Ref: CVLNC017

Proposed Core Valley Lines ("CVL") G1 Short Term Network Change: Cwmbargoed Branch Temporarily Out of Use (ELRs: PTA 13m 41ch to 15m 01ch, VON 12m 41ch to 13m 72ch and TBD 13m 68ch to 19m 59ch)

Appendix A

Short Term Network Change details

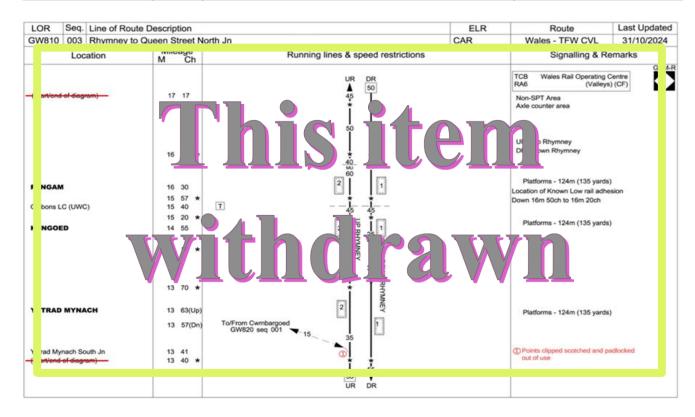
Physical disconnection of the signalling block by the signalling engineer:

- a block failure will be indicated to the signaller
- the block being disconnected will prevent the Ystrad Mynach end of the signalling system from communicating with the Cwmbargoed end thereby preventing any movement on or toward the branch line being signalled

Application of a route bar:

- In the WROC, a route bar will be placed on the signal leading to the branch line which will be recorded on a NR.3187 form with the signaller
- The signaller will place a reminder appliance on the signal
- The manual block release function will not be available

For the avoidance of doubt, points CF9415A and CF9415B will be maintained in an operational condition (in the normal position) and not secured. This is because:

- It is advantageous to keep these points in full working condition because they remain an integral part of the signalling system at Ystrad Mynach South Jn
- From experience, points which are secured for any length of time tend to deteriorate and become less reliable quite rapidly
- If these points were to be secured and should fail, the signaller would be denied the opportunity to operate them in an attempt to regain detection
- If these points should lose detection, then it will be quicker to diagnose and fix without the points being clipped/scotched
- Movements of rorail plant under possession can still be made to/from Ystrad Mynach to/from the rorail access point at 14m25ch on the Cwmbargoed line
